**CITY OF PORTLAND, MAINE
DEVELOPMENT REVIEW APPLICATION
PLANNING DEPARTMENT PROCESSING FORM**

Single Family S/F
Project Name/Description

Tucker Ave, Portland, Maine
Address of Proposed Site

From: Jay Reynolds
To: Doug Reynolds
Date: Wed, Nov 5, 2003 2:53 PM
Subject: Tucker Ave. review Comments

Drawing Name: Site, Grading & Wetland Fill Plan
Project: TUCKER AVENUE, PORTLAND

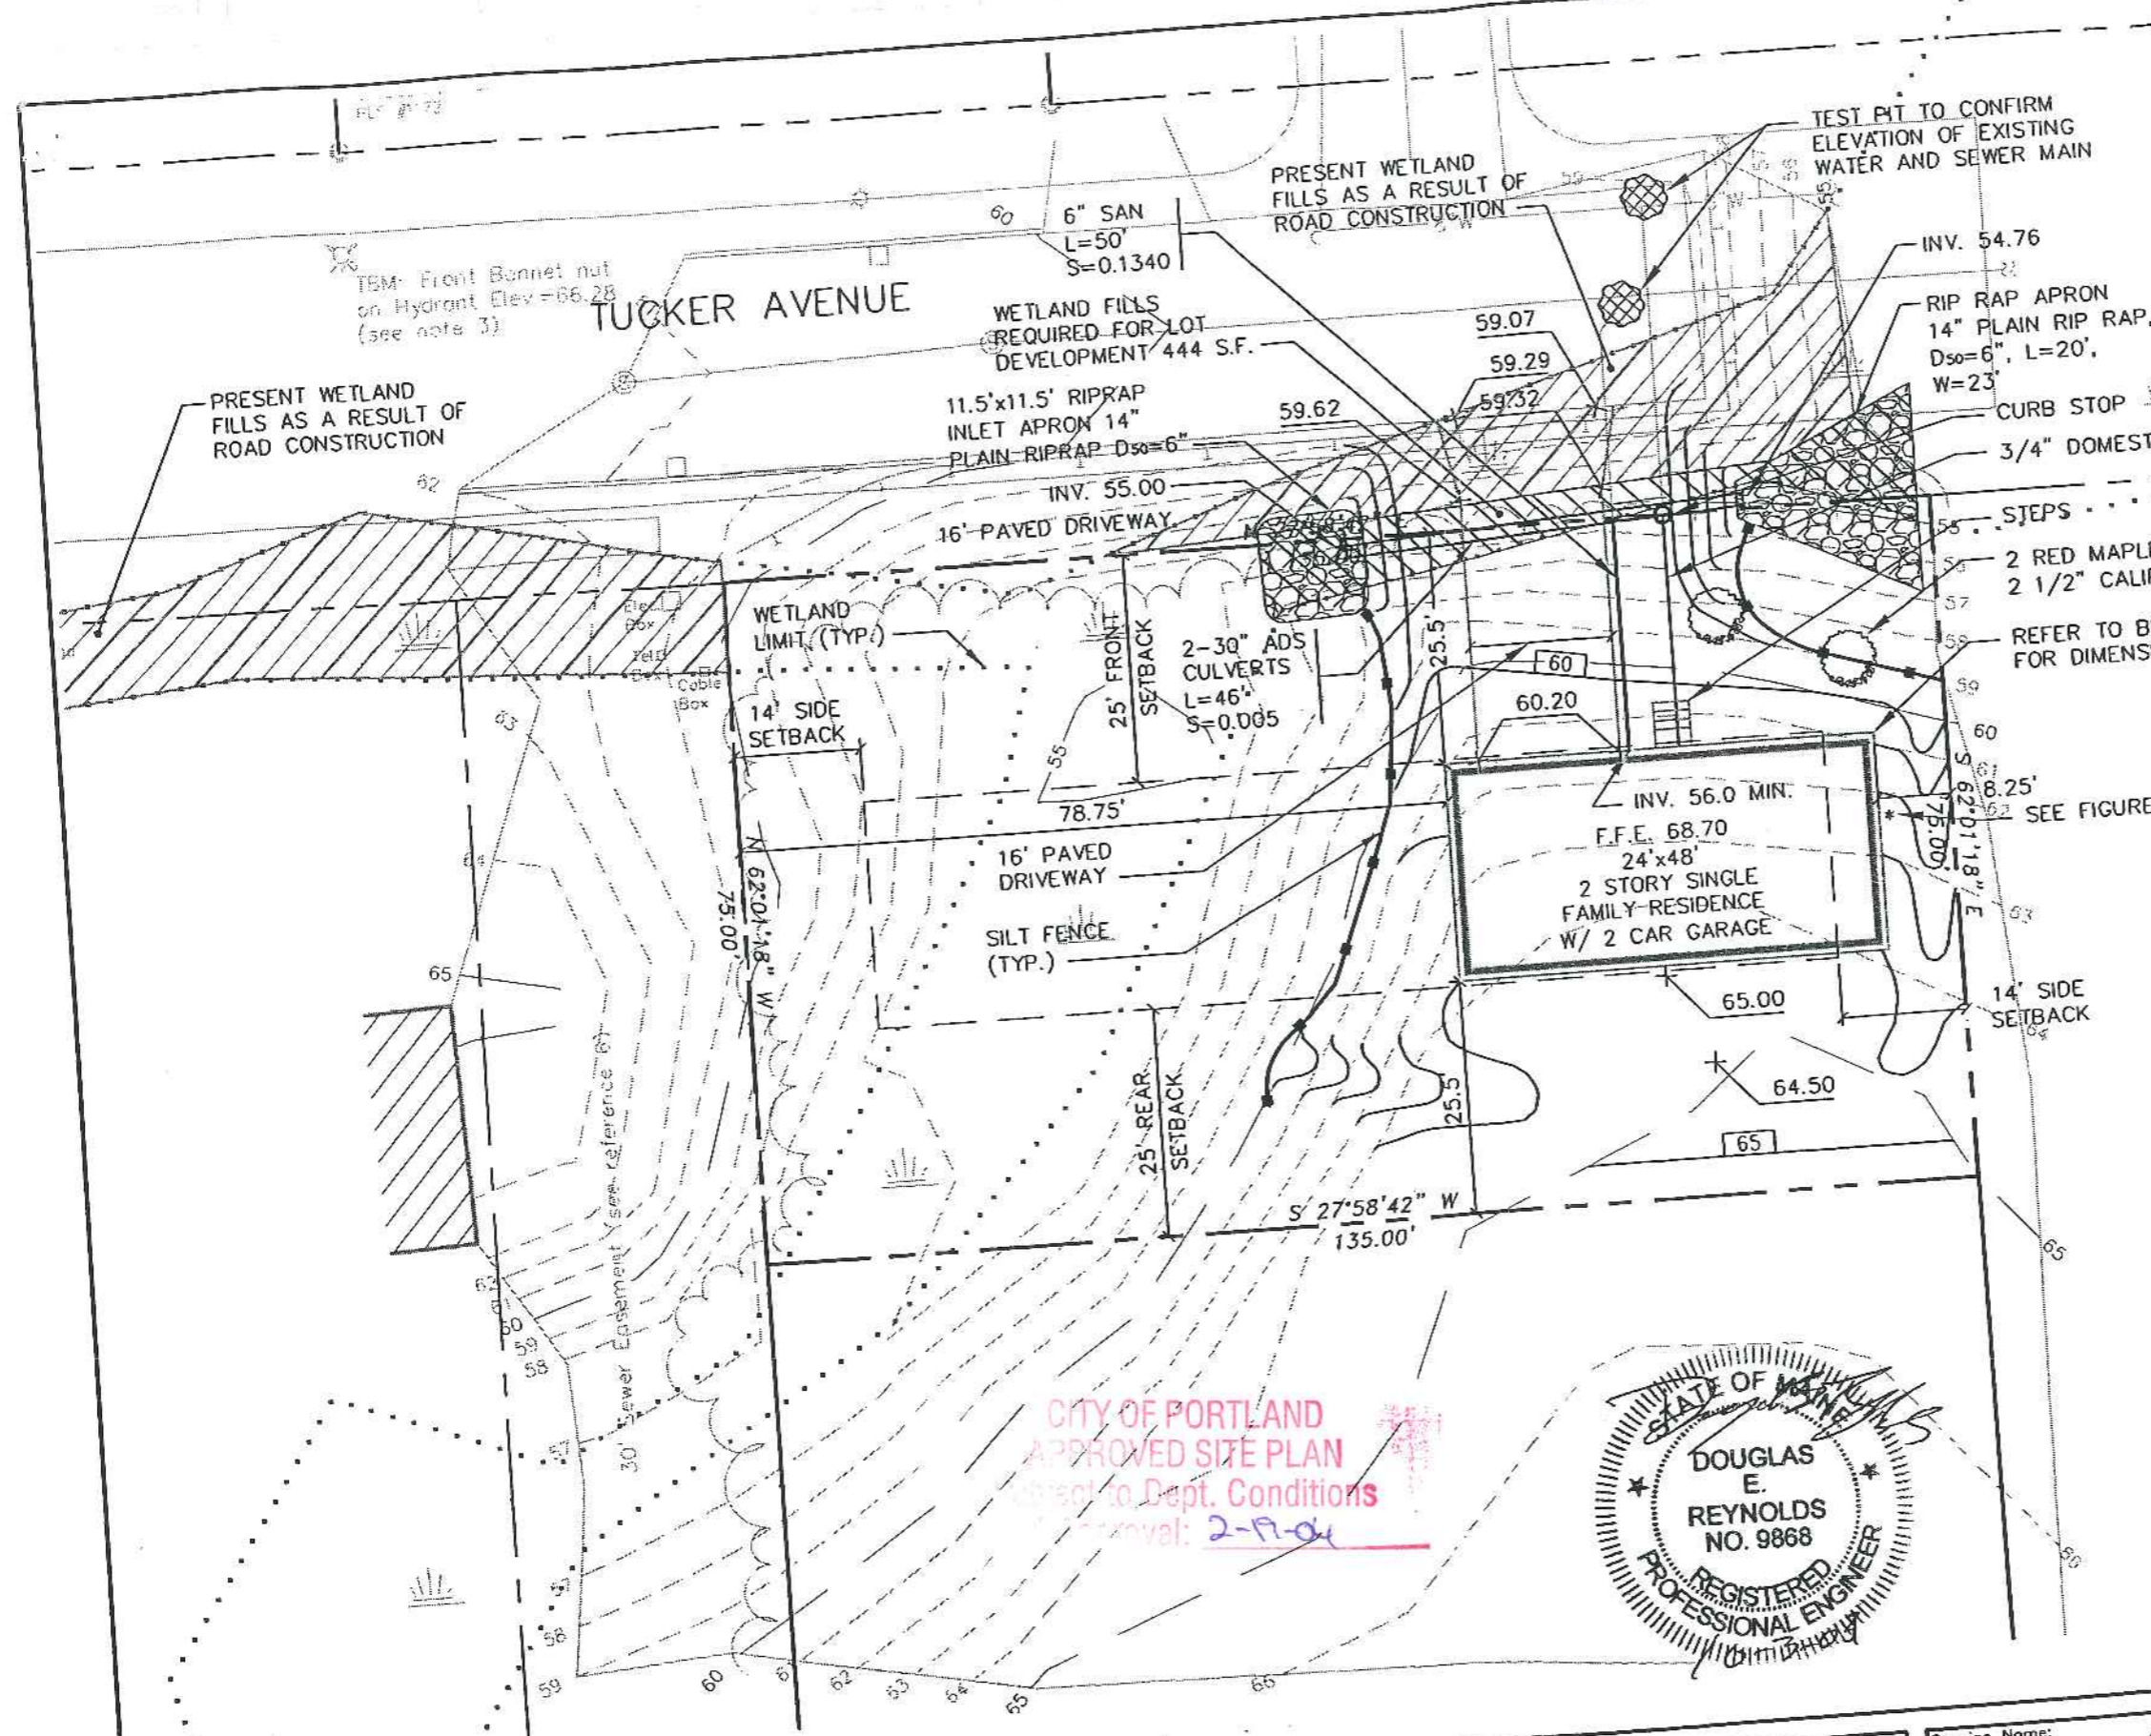
- 1. Zoning- this application would require extending the road per 14-403 requirements. *Respond in writing*
- ✓ 2. Is this an existing lot or are new lot lines being introduced? *Partial Permit / Public Works App.*

Tucker Ave: zoning is ok except for the 14-403 street - it looks like it needs to be extended to the end of the property (it is short of that now per the plans). Also, does public works want a turn around at the end?

1. Impacts on the adjacent wetlands appear to be severe if the applicant is made to extend the street by approximately 20 feet. While this issue is the applicants' concern, I am worried that the level of effort to extend the paved road frontage as requested will place an undue hardship on the applicant to properly mitigate the wetlands impacted from extending the paved area the additional 20 feet.

2. In reviewing background information the Public Works Department has on the Tucker Woods subdivision, it appears the developer was not required to extend Tucker Road past the entire frontage of Lot #9 within the Subdivision due to concerns the Planning Board had on impacts to existing wetlands area at the end of Tucker Avenue. Lot #9 was allowed to be constructed with approximately 70 feet of unpaved road. The Dowd lot is directly across the street from this lot, and although the Dowd lot is not a part of the Tucker Woods Subdivision, the same issues and concerns apply regarding impacts to the existing wetlands by extending the street.

3. The Public Works Department endorses Section 14-403 of the Zoning Ordinance; however, we do not feel in this case that filling of the wetlands to extend the pavement by 20' provides the operational and maintenance benefit for the City inherent with this Zoning requirement.

Jay,
On 2/5/04 the Zoning Board of Appeals approved the variance for this property. They do not have to extend the street to the end of their property. Where are you on the approval? I will be signing off on it soon.
Marge
